ANALYSIS OF PROPOSED AMENDMENTS IN CONSIDERATION OF THE MIAMI BEACH CODE AND THE SECRETARY OF INTERIOR'S STANDARDS AND GUIDELINES

- Heritage Architectural Associates reviewed the project documentation that was included in the submission for the hearing before the Miami Beach Historic Preservation Board on November 9, 2021.
- The project specifications were compared with the Miami Beach Historic Preservation Ordinance and the Secretary of the Interior's Standards for Rehabilitation and Guidelines for Rehabilitating Historic Buildings.
- Based upon the review of the above referenced documentation with the criteria set forth in the Historic Preservation Ordinance set forth above, in our expert opinion, the request for the Certificate of Appropriateness should be denied based upon the following items of non-compliance:

*Figure 26. Existing shadowing at Equinox, 10 a.m., October 2021.
(Heritage Architectural Associates with K4 Architecture)*

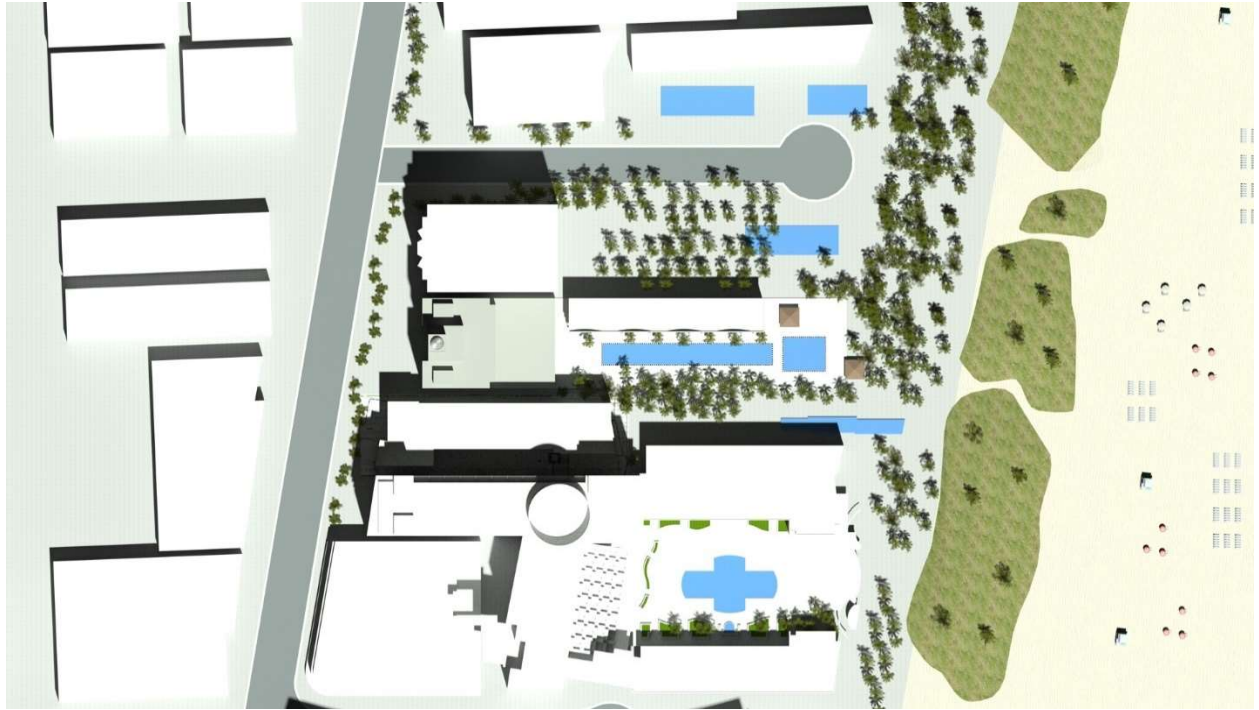
In a district in which the design response to light is an essential component of historic architectural fabric, the adverse impact of giant shadows upon contributing buildings is significant. This impact strikes at one of the essential characteristics of the historic architecture of Miami Beach.

- The tower would create shade that would adversely impact adjacent contributing buildings, especially the National Hotel, that were designed to be seen and function in light.
- The tower would also impact views from the neighboring National Hotel.
- The proposed project is located in the **HEART OF THE DISTRICT**, adjacent three iconic towers – the National, Delano and SLS (former Ritz Plaza) – that have iconic visual significance and integrity.
- Placing a 200' tower in this location will adversely impact this “postcard” skyline.
